NTSB Questions DR 129:

- Unity plots/graphs developed by Enbridge personnel during their performance analysis of the 2011 hard spot ILI data (Linalog® HR Plus & Hard Spot with INS/GPS ILI tool run in April of 2011)

Revised and Supplemental Response:

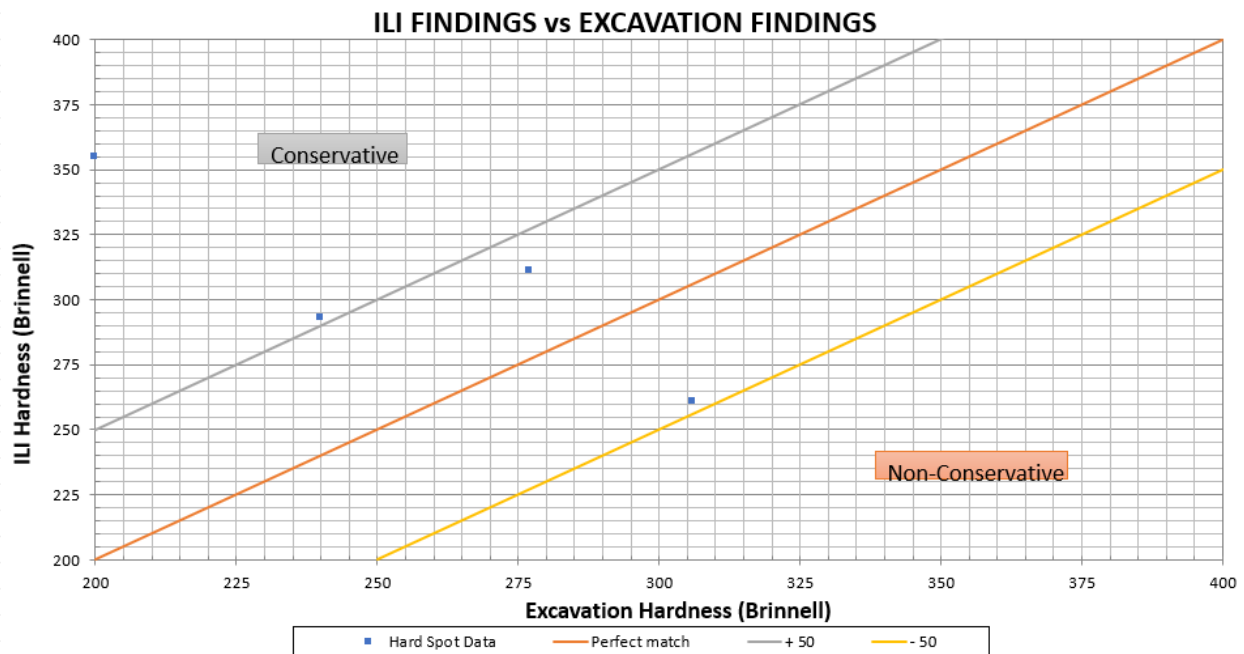
- A unity plot of the excavation results was generated in 2019 after the incident, and is provided below for the comparison of ILI and excavation findings in 2011:

Note: The ILI reported hardness for WC 244877.9 was 355 HB, and the excavation maximum hardness was 160 HB. For Unity plot purposes an excavation hardness of 200 HB was used due to graphing issues.

- All ILI reported hard spots in 2011 greater than 300 Brinell (HB) were excavated, as well as one hard spot with ILI estimated hardness of 293 Brinell. The remaining reported hard spots had estimated hardness of 261 HB or less. Three excavations were performed in 2011, to address 4 hard spots shown in the Table below:

The updated unity plot after the incident is provided below:

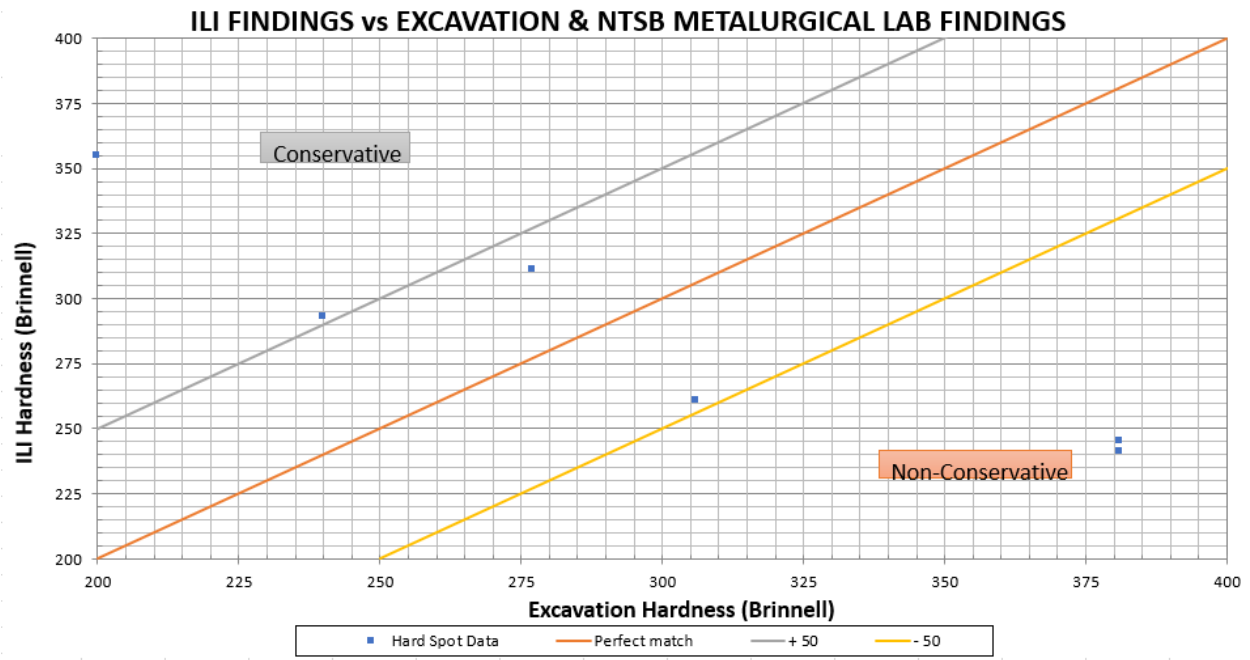
The two non-conservative data points represent the Lincoln County incident origin hard spot. The ILI reported possible hard spot at WC 376895.967 was investigated with polishing and etching at the reported location, however no hard spot was found. It is represented in the table as 0 for metallurgical lab hardness; however the value 0 is not within the scale boundaries of the unity plot.

- Enbridge has requested additional testing of 6 hard spots (between WC 376895.508 and 376903.633) on the incident site samples at NTSB metallurgical lab in order to further assess the remaining possible hard spots identified by the ILI vendor during the re-analysis of the 2011 ILI data. The possible hard spot at WC 376911.425 is at NTSB facilities, however the sample was on a spool in the crater and was subjected to the effects of prolonged heat exposure. Testing of these data points would provide additional hardness values for the unity plot.
